TENNESSEE TECHNOLOGY CORRIDOR DEVELOPMENT AUTHORITY

REPORT OF STAFF RECOMMENDATION

File Number: 9-C-19-TOB

Applicant: DANMAR DEVELOPMENT

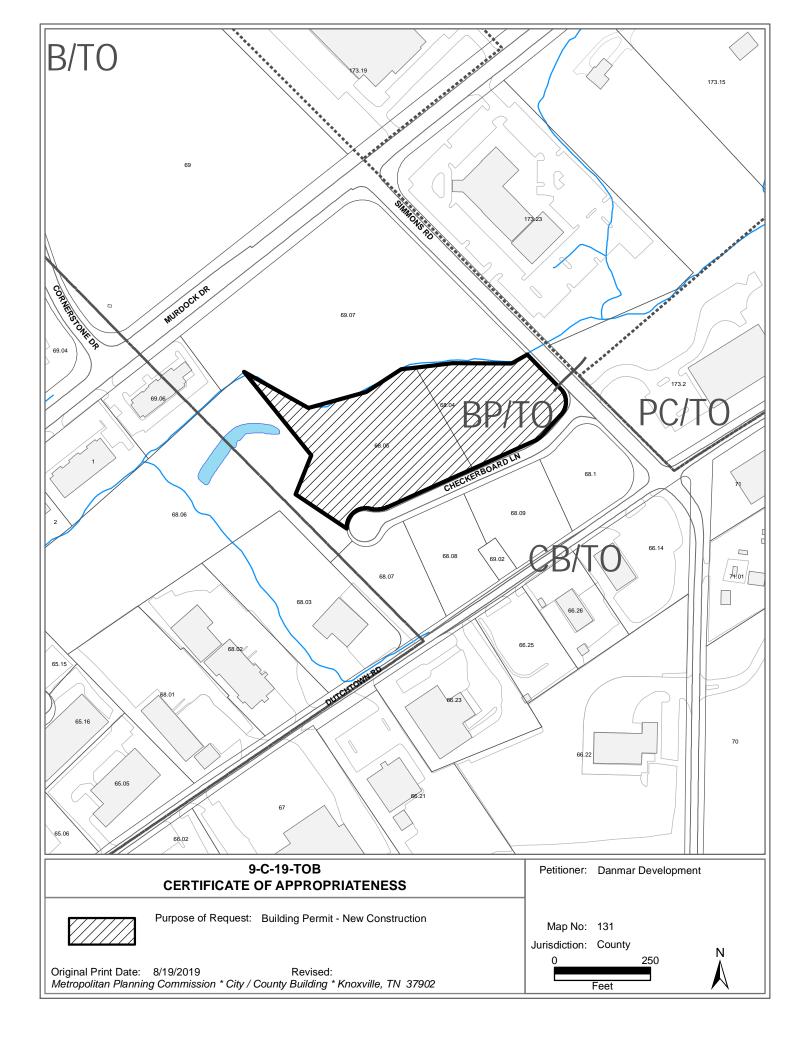
- 5) The mechanical equipment areas are required to be screened from view from the public streets. Screening plans still need to be provided to staff for approval. Additional screening is also needed for the proposed dumpster location.

- 6) The proposed landscape plan needs to be modified to include additional ornamental trees and shrubs on the eastern side and southeastern corner of the warehouse building in order to be in compliance with the Design Guidelines.

- 7) While minimal lighting is proposed for this site, a site lighting plan is still required to show compliance with the Design Guidelines.

- 3) Submitting a revised landscape plan to staff for approval that includes additional ornamental trees and shrubs on the eastern side and southeastern corner of the warehouse building in order to be in compliance with the Design Guidelines.

- 5) Meeting all applicable requirements of the Knox County Department of Engineering and Public Works.
- 6) Submitting a revised development plan that provides additional screening for both the mechanical equipment and dumpster area subject to stall approval.

- 7) Submitting a site lighting plan that is in compliance with the Design Guidelines subject to staff approval.
- 8) Any proposed signage will require a separate TTCDA application and approval.

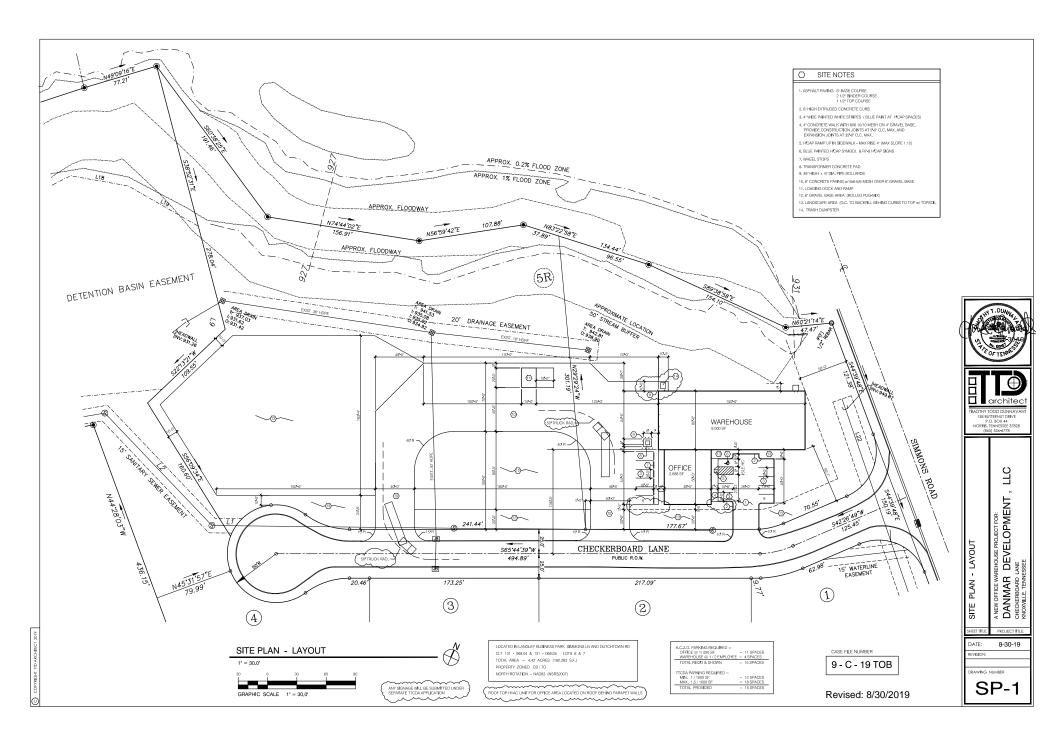
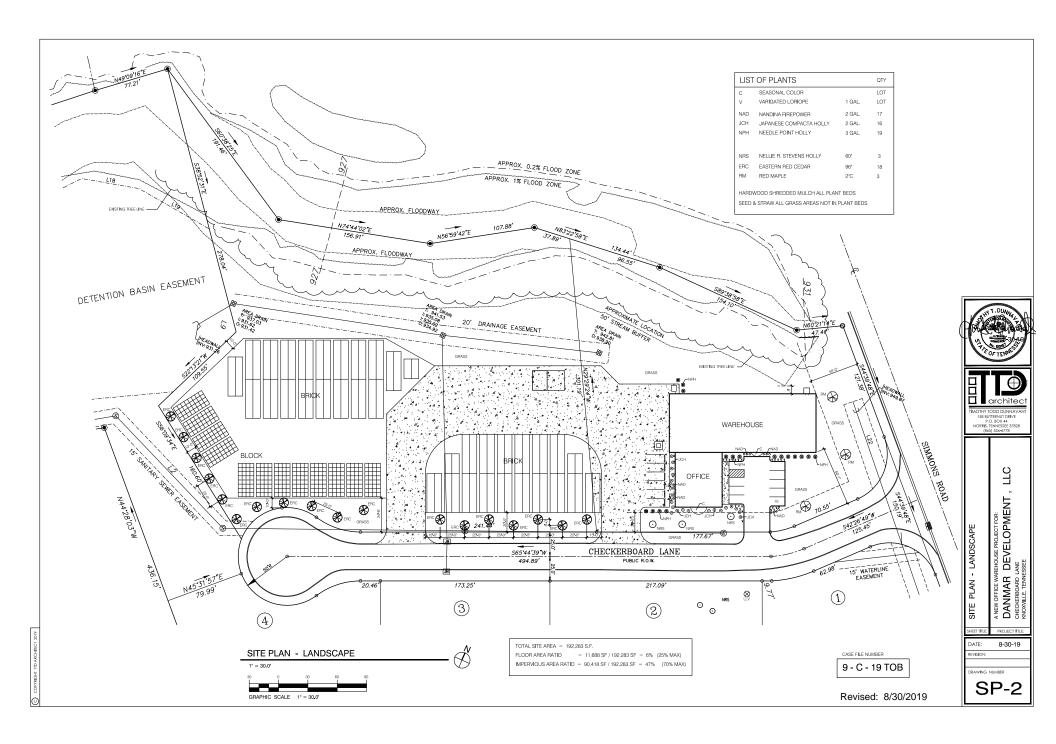
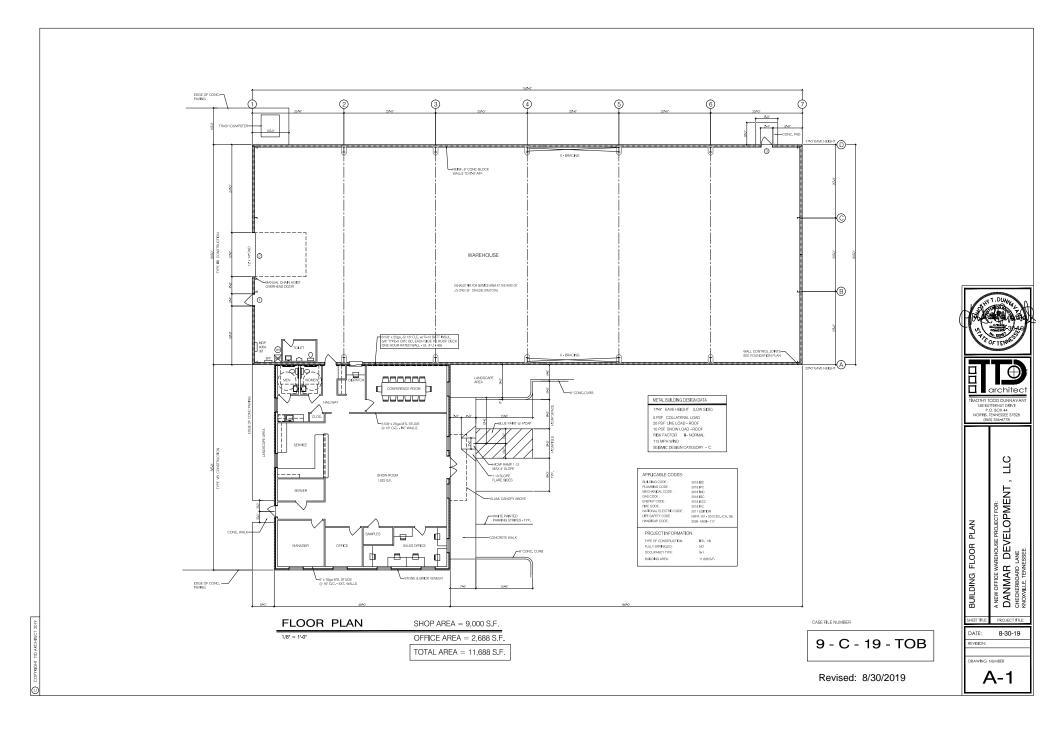
- 3) The proposed development is within the limits for Ground Area Coverage, Floor Area Ratio and Impervious Area Ratio.
- 4) The exterior siding for the office/showroom building will include a mix of stone and brick veneers with additional masonry banding and window treatment. The warehouse building will include both split and smooth face CMU with vertical metal wall panels. The window and entrance areas include an aluminum storefront system finished in medium bronze. A suspended canopy will be provided over the main entrance. The roof system will be a standing seam galvalume roof.
